**Recommended Amendments to the  
2006 International Residential Code**  
North Central Texas Council of Governments region

The following sections, paragraphs, and sentences of the *2006 International Residential Code* are hereby amended as follows: Standard type is text from the IRC. Underlined type is text inserted. ~~Lined through type is deleted text from IRC.~~ A double asterisk at the beginning of a section identifies an amendment carried over from the 2003 edition of the code and a triple asterisk identifies a new or revised amendment with the 2006 code.

Figure N1101.2 TEXAS CLIMATE ZONES

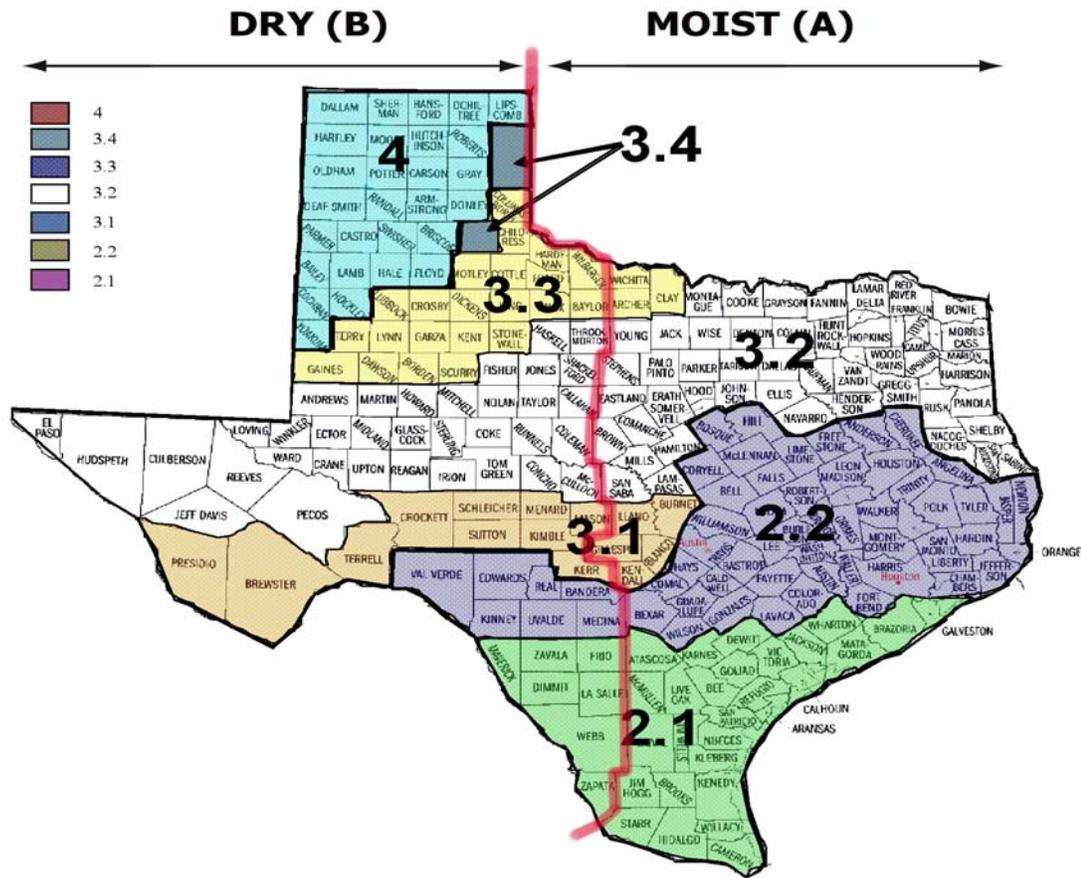
\*\*\*Replace Figure N1101.2 to read as follows:

(Reason: This amendment is added to satisfy the “not less restrictive” requirement when adopting subsequent editions of energy codes in accordance with Texas SB 5, 77<sup>th</sup> Legislature.)
